# Final Decision

## Planning Commission

**File number(s):** DR 23-03, PLA 23-03, SA 23-02, & VAR 23-05

**Project name:** Commerce Way Industrial Park

SHEET TITLE:  
EXISTING PARCEL  
CONFIGURATION  
AND EASEMENT  
PLAN

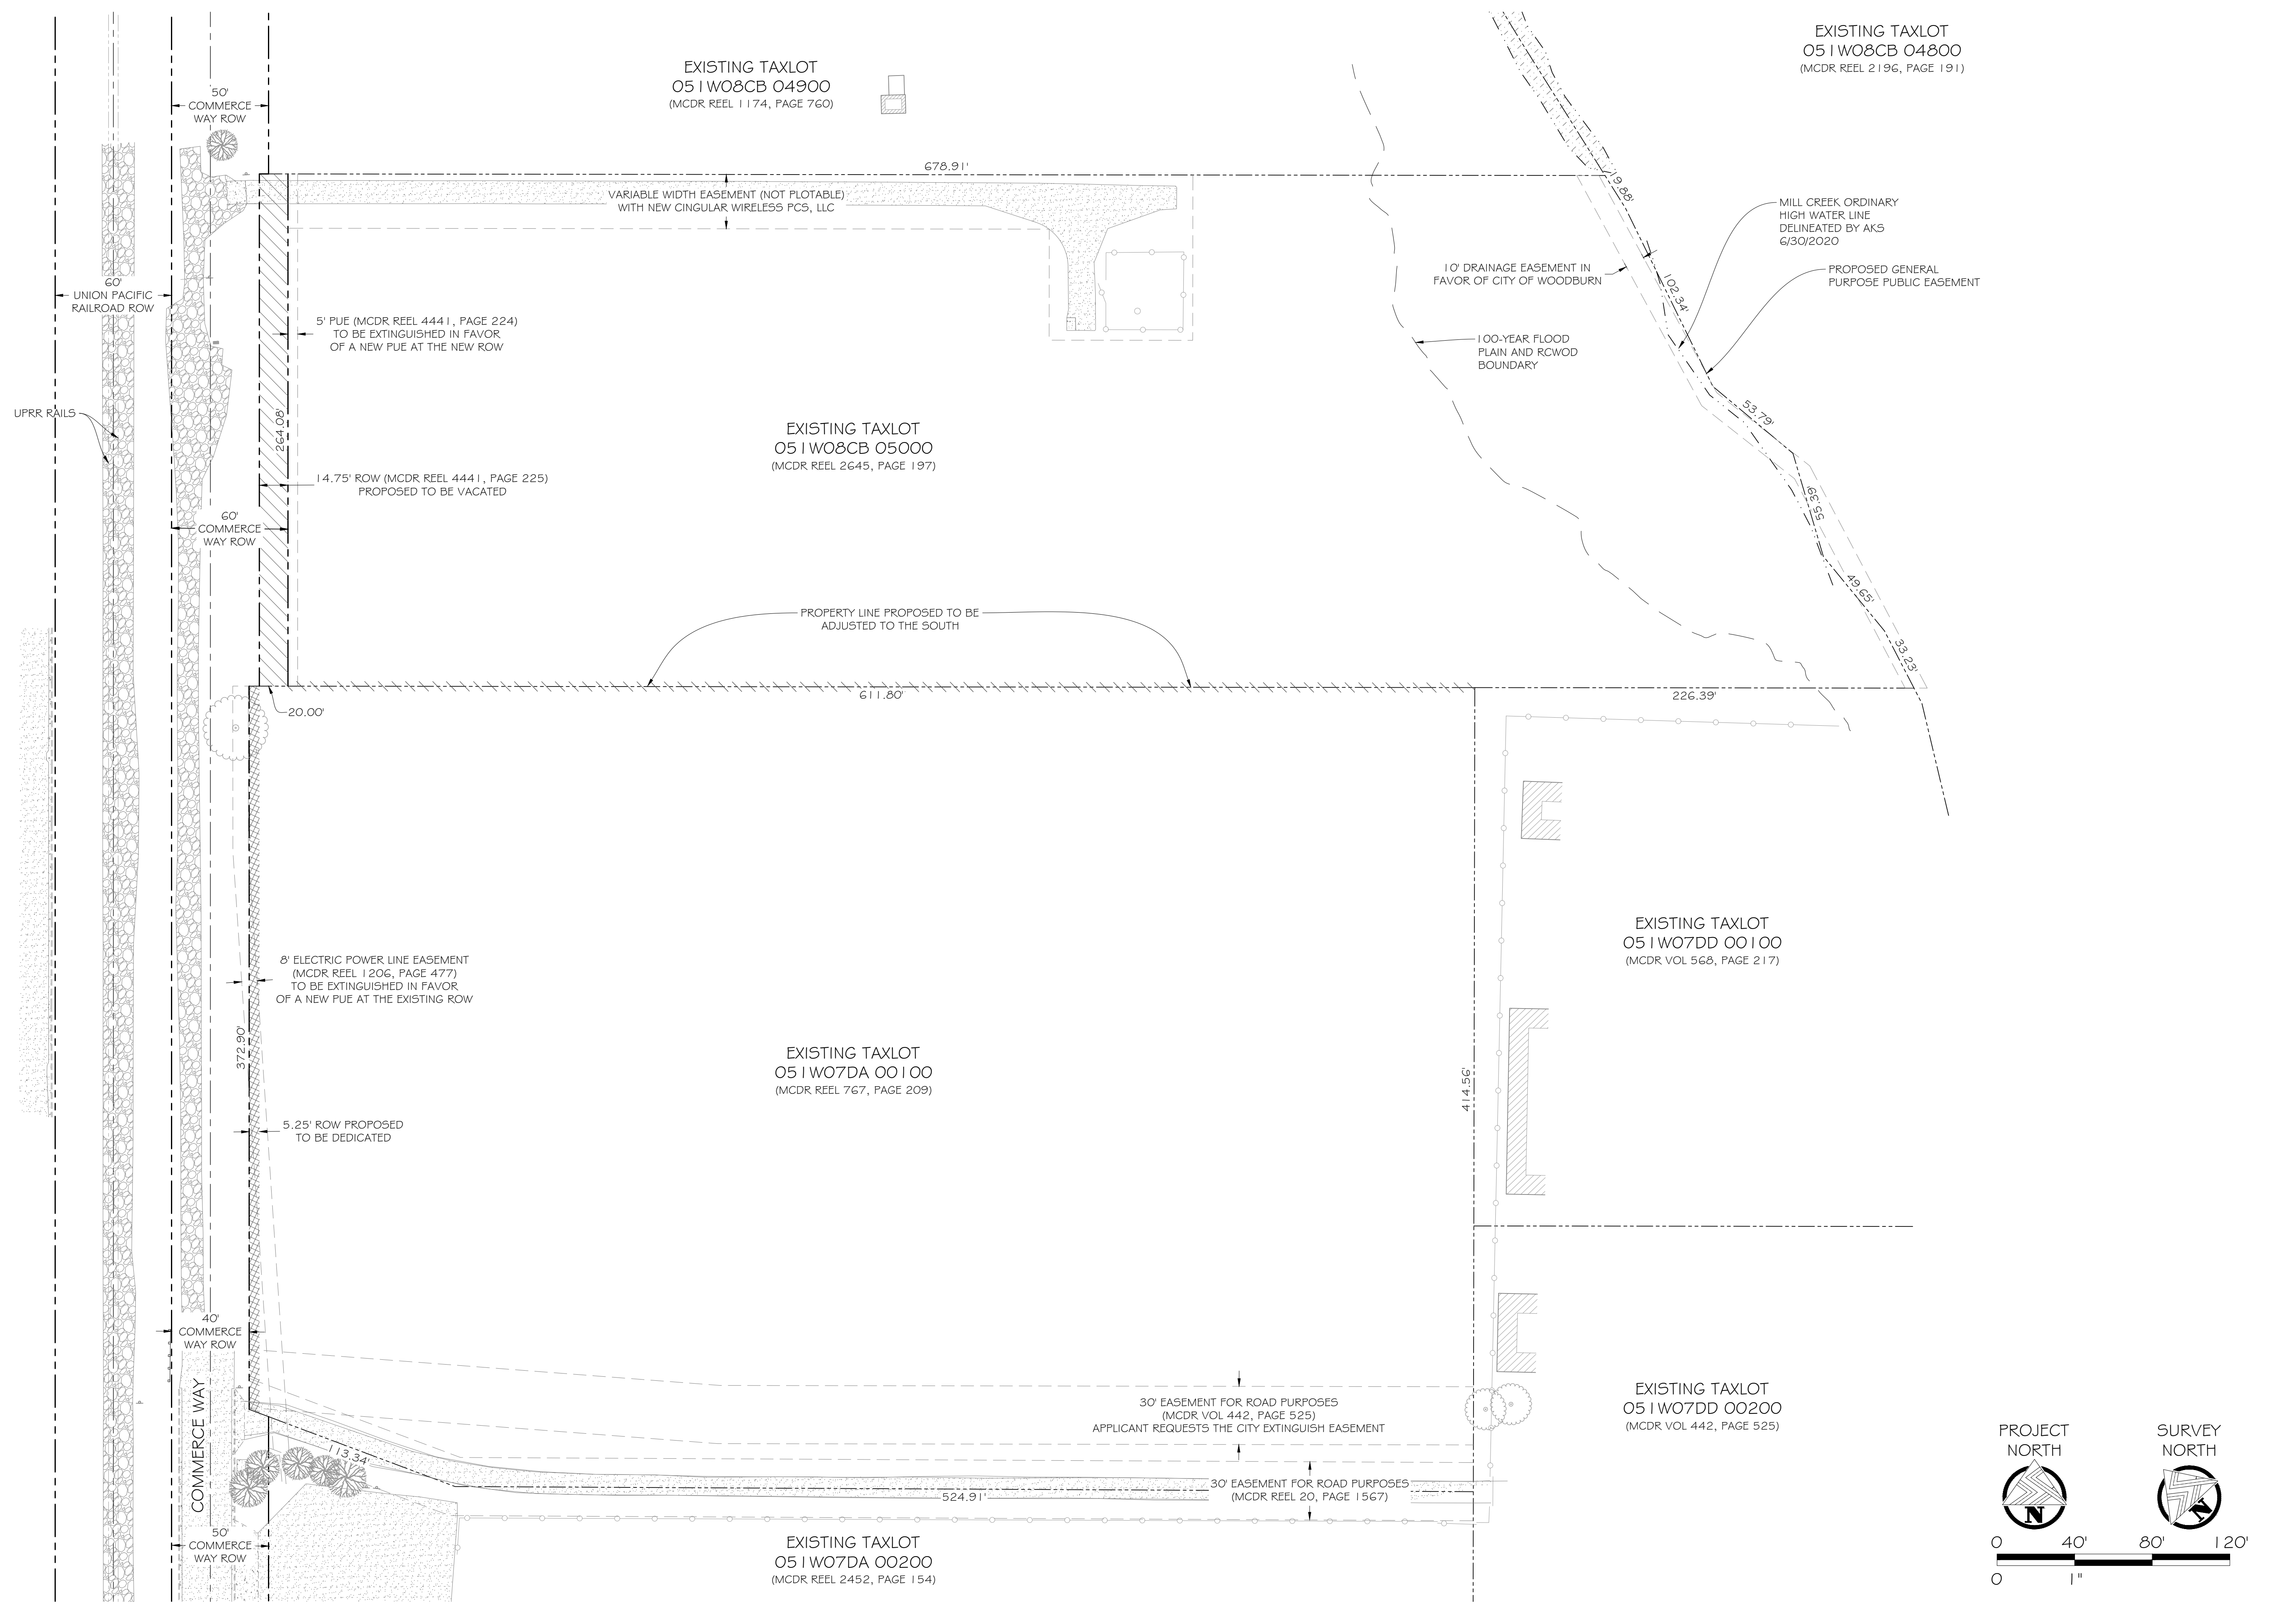
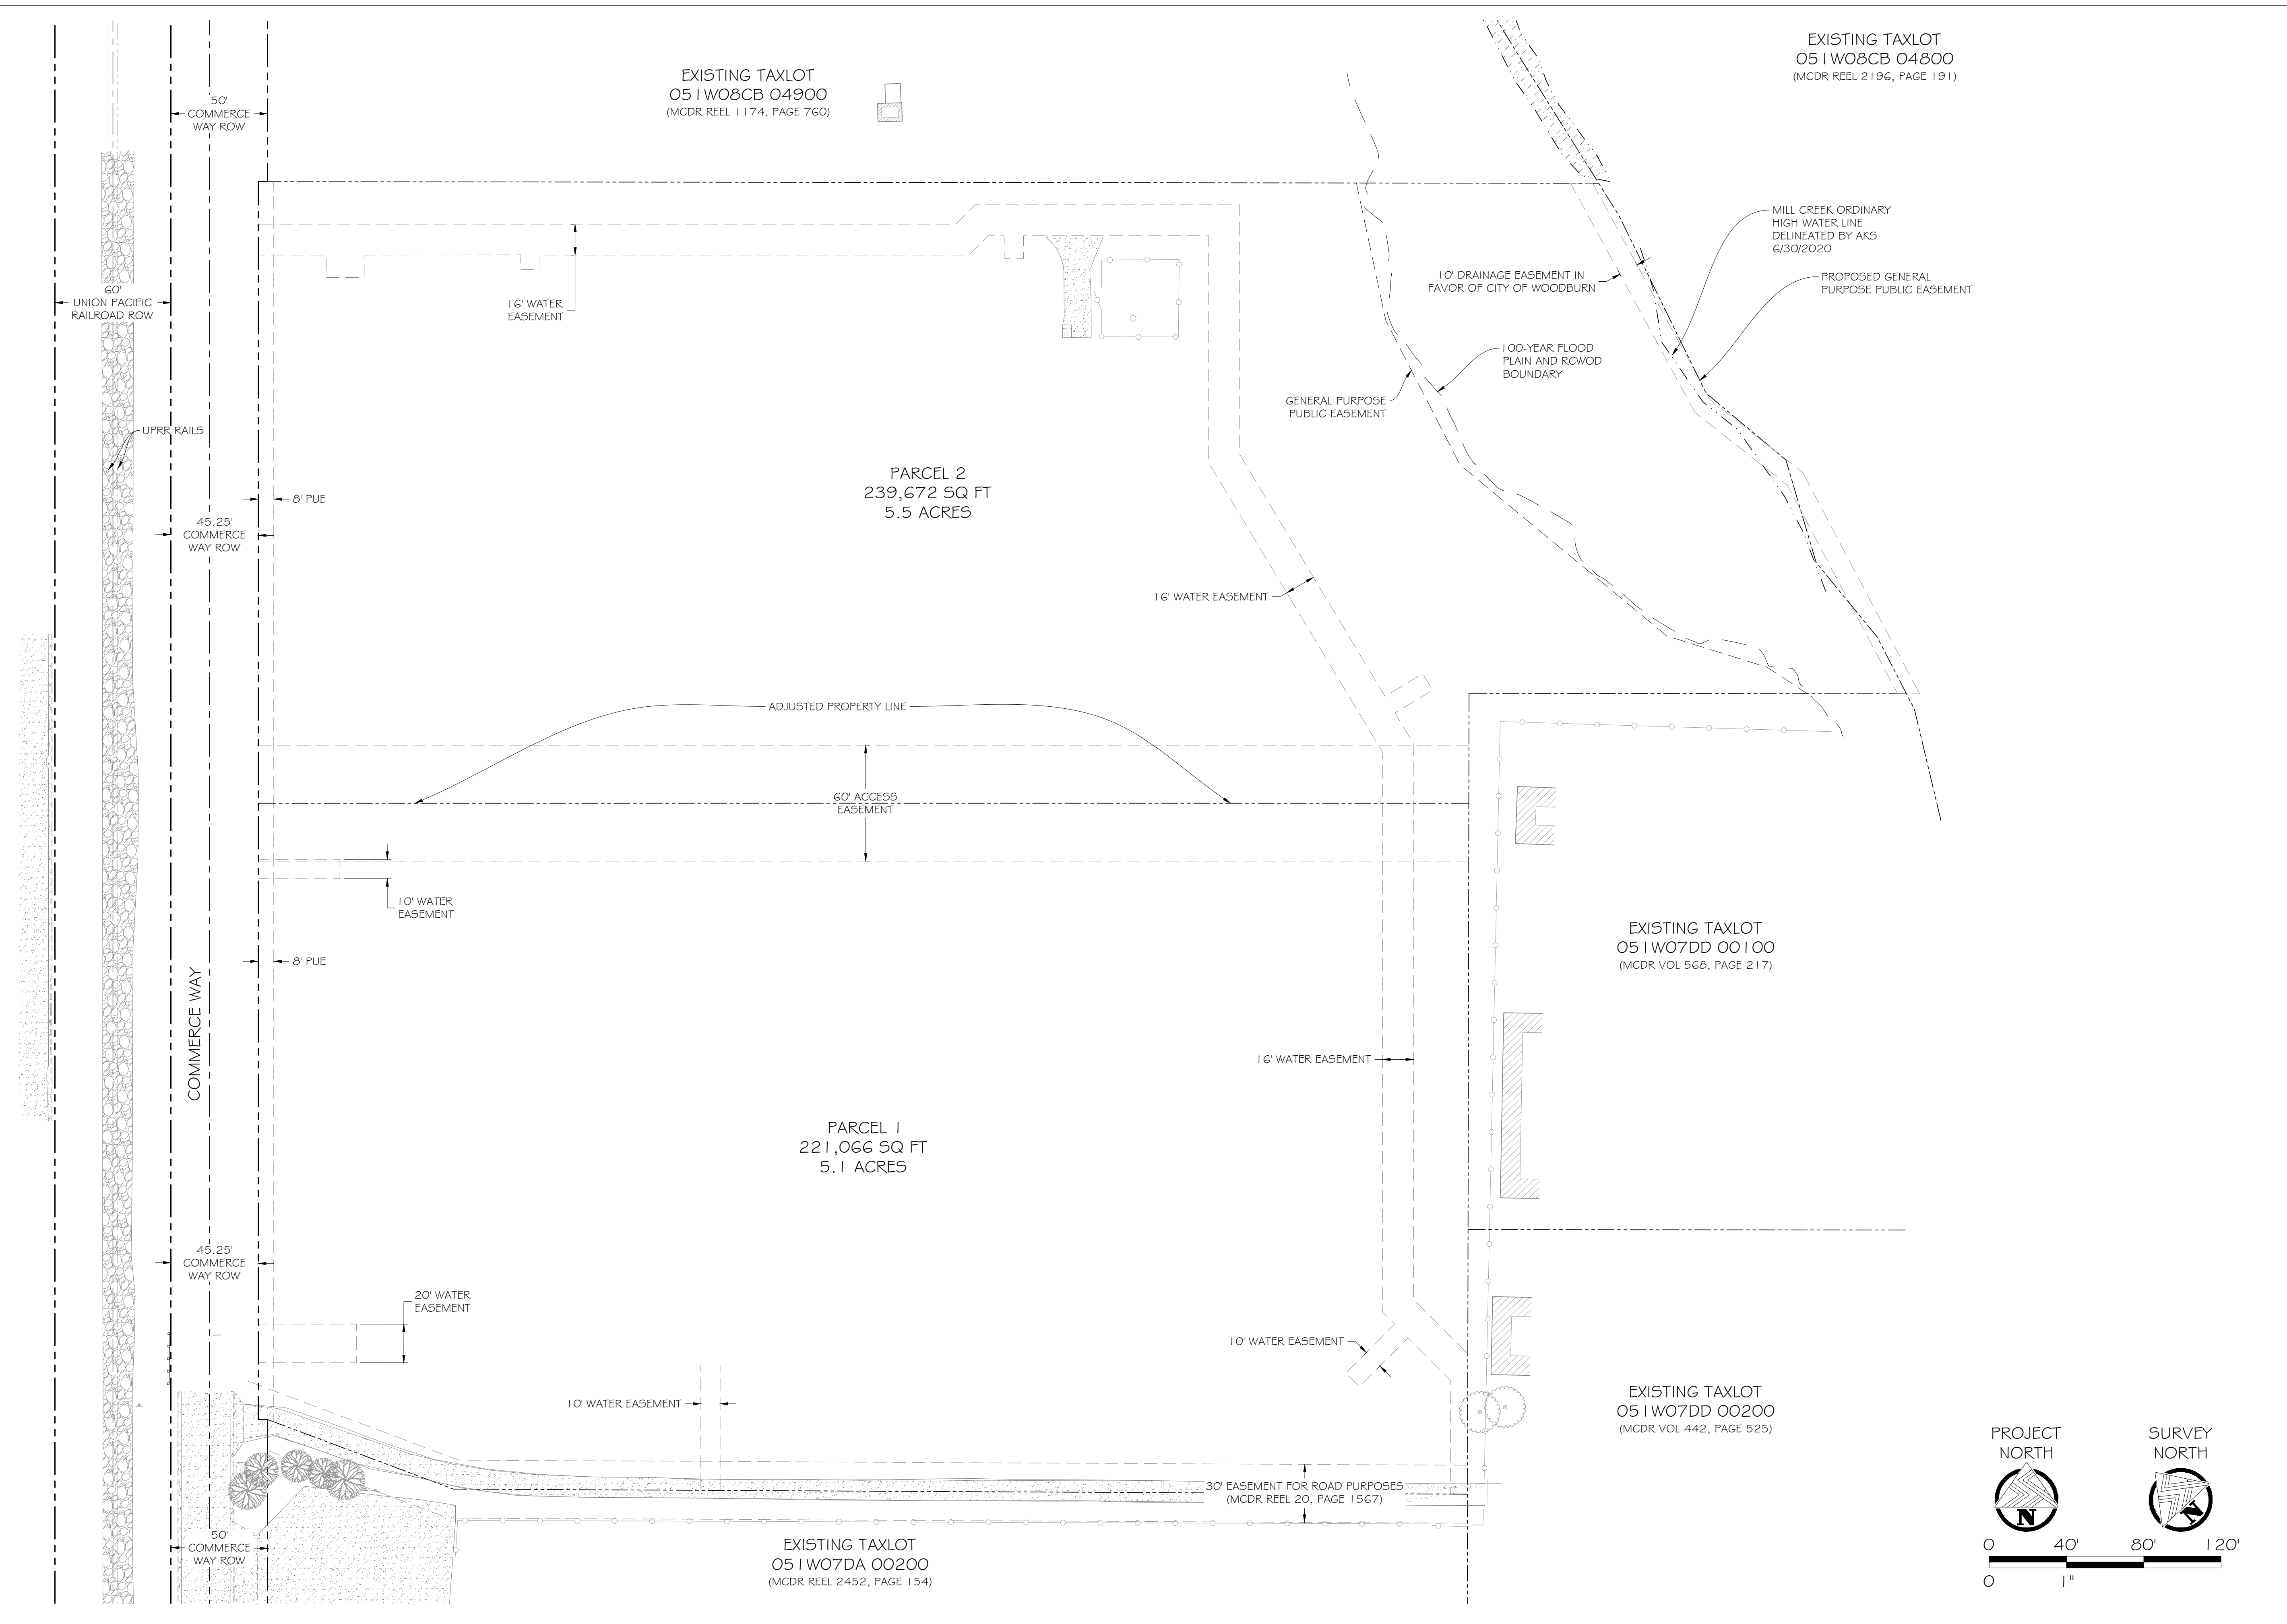
8. **Right-of-way dedication:** Developer shall dedicate Commerce Way right-of-way for Tax Lot 100, as illustrated on Sheet C-1.03. Dedication would occur concurrently with recordation of the property line adjustment.
9. **Easements:** The developer shall grant the following easements concurrently with recordation of the property line adjustment. Prior to recordation, submit a draft copy to the City for review.

10. Vacation requests: Application materials illustrate and note certain vacations being requested (see Sheet C-1.03). Prior to recordation of the property line adjustment and prior to civil plans approval for public improvements, the developer shall successfully complete the vacation process for the following:

- a. The requested right-of-way along Tax Lot 5000; and
  - b. The requested 30-foot-wide easement within Tax Lot 100 (MCDR Volume 442, Page 525).

SITE PLAN

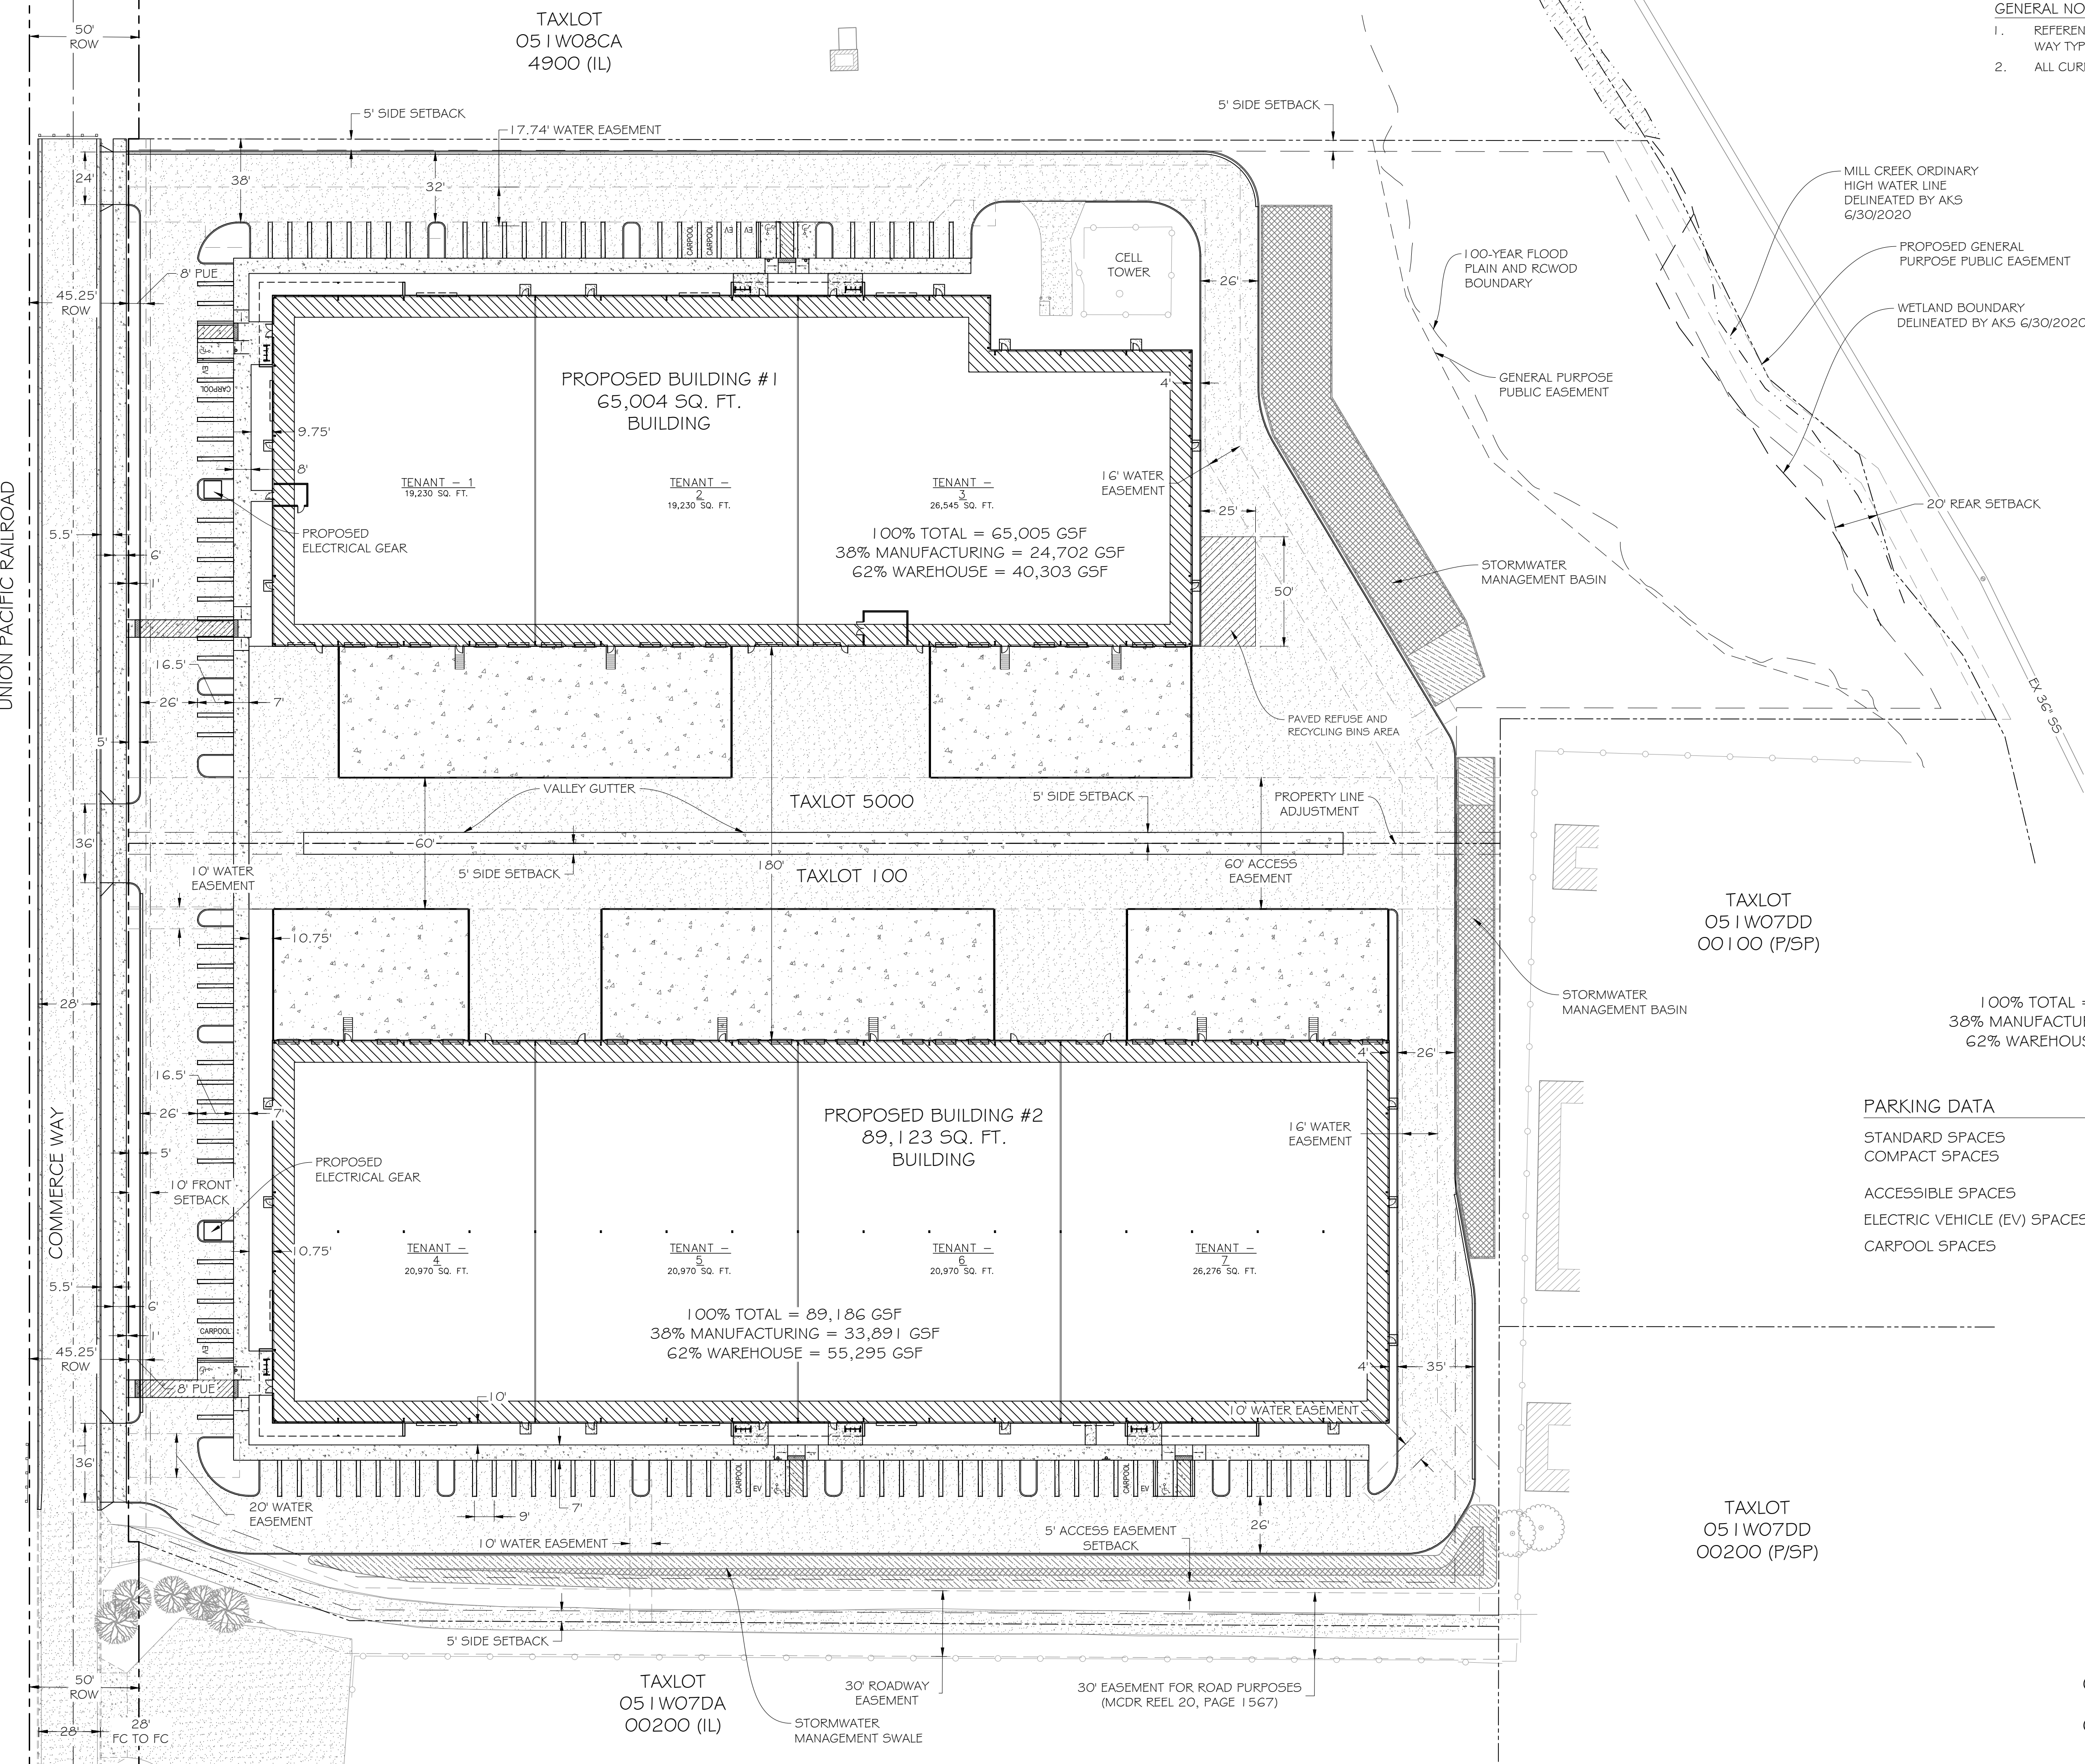
- a. Improvements: Construct street improvements to match the cross-section on Sheet C-0.03 and the site plan on Sheet C-1.07. Improvements are due prior to building permit issuance.
